**DESIGN
REVIEW
BOARD**

6-A-25-IH

APPLICATION FOR CERTIFICATE OF APPROPRIATENESS

3112 Rector St.
Lonsdale Infill Housing Overlay District

Front Exterior Elevation
Scale: $\frac{1}{4}" = 1'-0"$

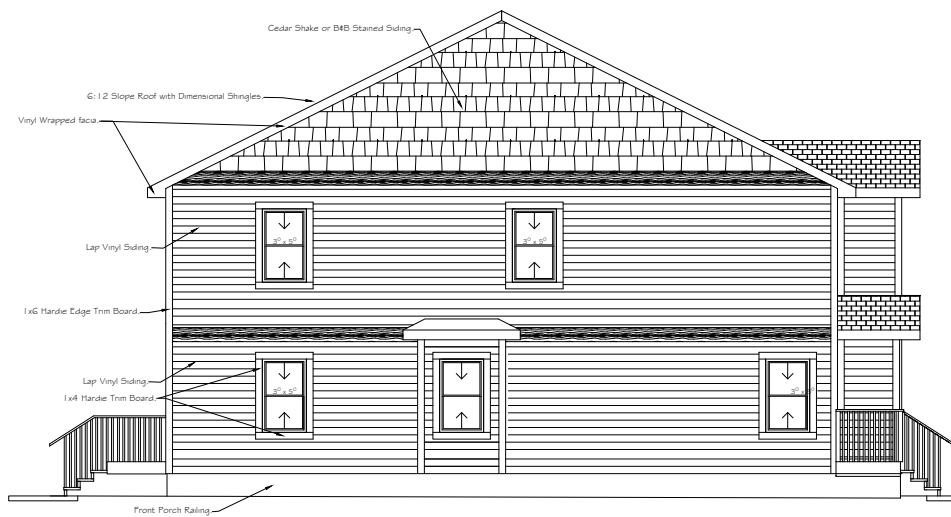
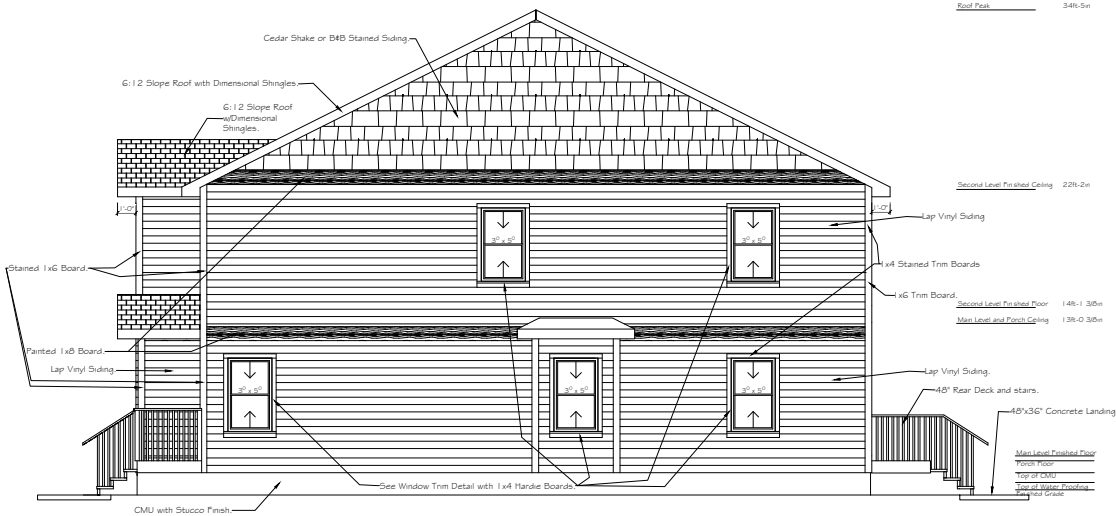
3. The guidelines for multi-unit housing recommend that "new multi-family buildings be designed in scale and context with the early architectural features of the neighborhood." The block to receive new construction is characterized by Craftsman bungalows, modified Queen Anne cottages, and infill construction. All houses on the block are one story. The duplex is proportionate to the dimensions of the lot and generally proportionate to other houses on the block. It does not incorporate any details which align with the architectural context.

8. Guidelines recommend window and door styles be similar to historic houses on the block, with similar placement and ratio of solid to void. While all four elevations feature sufficient transparency for the historic context, some revisions may be necessary to better align the buildings with the historic context (including the irregular placement of windows on the side elevations).

9. The elevation drawings feature vinyl lap siding with brick veneer and either shakes or board-and-batten accents and a stucco-clad CMU foundation. The siding should feature a horizontal overlap similar to wood siding instead of Dutch lap or flush panels.

The Board should discuss the proposed height and depth of the duplex within the neighborhood context. Along with any necessary revisions or conditions, staff recommends approval of Certificate 6-A-25-IH, subject to the following conditions: 1) final site plan to meet City Engineering standards, with major changes to the site plan to return to the Board; 2) front setback to be revised to align with the front setback pattern of the blockface; 3) final site plan to include a native or naturalized shade tree in the front and rear yards; 4) meeting all relevant standards of Article 4.6. and Article 9.3.J., with minor revisions to be approved by staff.

Left Exterior Elevation
Scale: $\frac{3}{8}'' = 1'-0''$

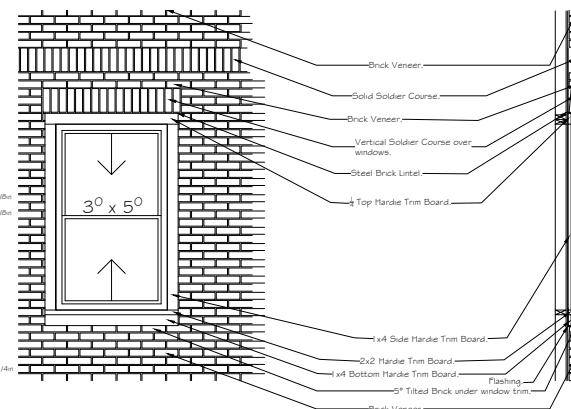
5. The 35'-4" wide duplex is compatible in façade width with original houses in the neighborhood and meets the maximum building width requirements in Article 4.6, Middle Housing standards, for a side-by-side duplex. However, the duplex is approximately 5-10' deeper than the other houses on the block. The side elevations are large in scale but attempt to break up the massing with a bay window on each side and trim separating each story. The building is within the maximum depth for a side-by-side duplex in the Middle Housing Standards. Guidelines also recommend that multi-unit housing be similar in height to original houses on the street. The two-story building is taller than the surrounding context, as the block only features one story houses. The duplex also features a 2' tall foundation, which increases the building's overall height. The Board should discuss the height and depth of the duplex.

7. At least a 6/12 roof pitch is required in the Middle Housing standards to fill the "steep" category of roofline; 6/12 is also the minimum pitch approved by the Infill Housing guidelines. The large building may also benefit from additional variations in roofline, particularly on the larger side elevations.
